Company	Trenz Electronic GmbH
AVNNumber	AVN-20230623
Title	AVN-20230623 TE0802-02-1AEV2-A
Subject	Incorrect specification for placement option
Issue Date	20230623

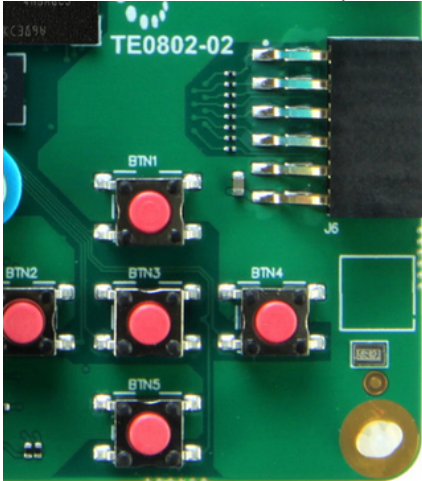
Artikelname ist TE0802-02-1AEV2-A and Serial number is from 747463 to 747962. Serial number is on the small white Sticker with QR Code, which is placed here:
